System Impact Assessment Report

Project: Newpost Creek Hydraulic Generation
Applicant: Ontario Power Generation Inc.

CAA ID 2007-294

November 10, 2010

Figure 1: Connection Arrangement for Newpost Creek GS

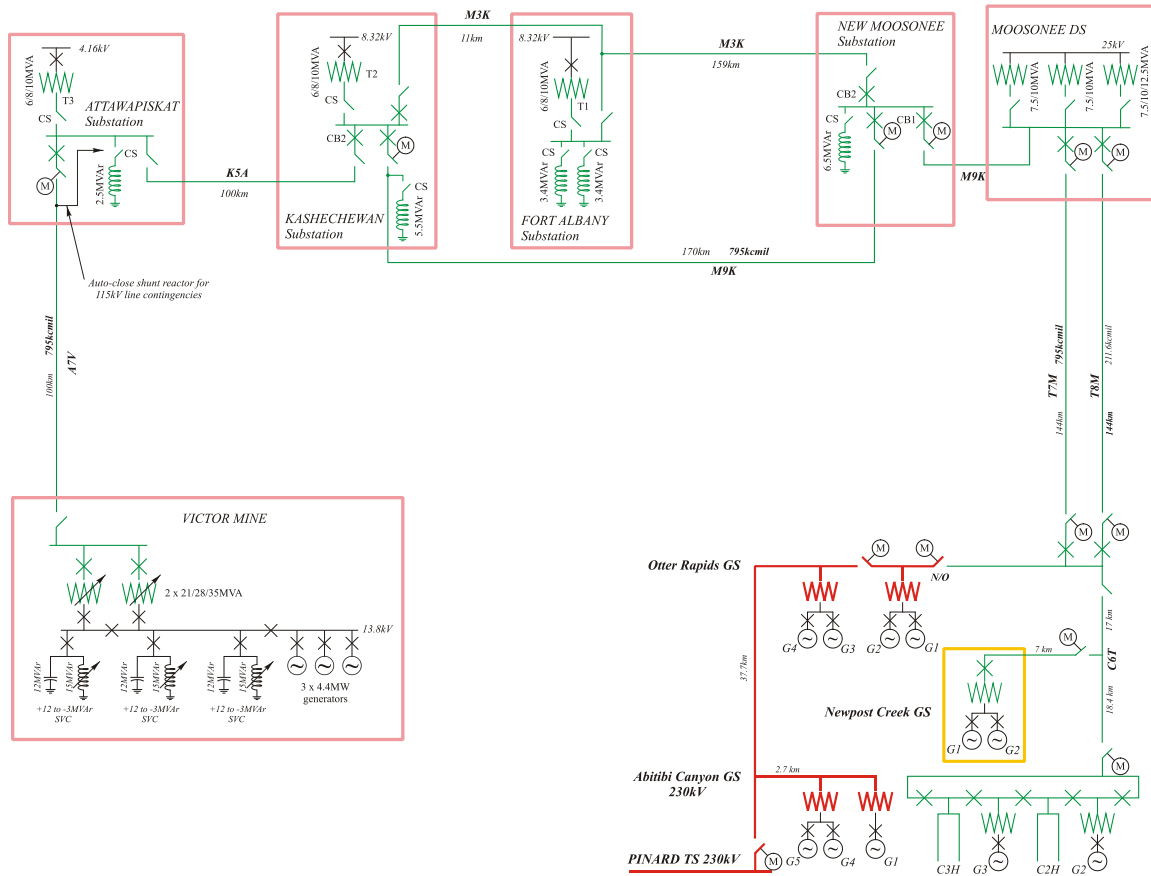
OPG must install a motorized disconnect switch at the point of connection to the existing IESO controlled grid.

Figure 2: Block Diagram of Excitation System

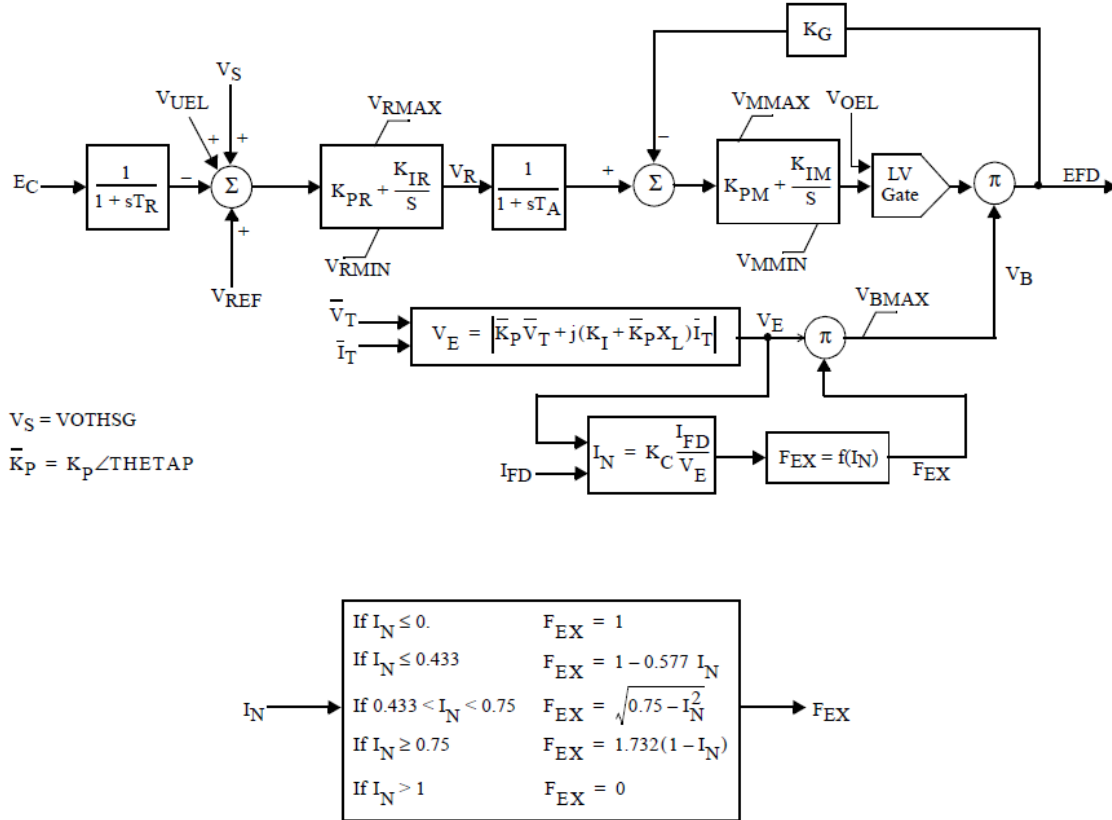
The block diagram of the proposed excitation system (Figure 2) shows the impact of I_{FD} on the E_{FD} . Using the settings shown in Table 2, at rated terminal voltage, V_E will be 5. Assuming $I_{FD} = 1.6$, results in $F_{EX} = 0.98$. Then, $V_B = V_E \times F_{EX} = 4.9$. Therefore, E_{FD} can be as high as 4.7 pu ($V_B \times V_{MMAX}$) which is 205% of rated field voltage which meets Market Rules requirements.

It should be noted that the performance of the exciter is obtained based on the estimated data.

The connection applicant is required to ensure that the performance of the equipment that is eventually supplied and installed is similar to the predicted performance or exceeds the predicted performance observed in the simulation results obtained using the above models.
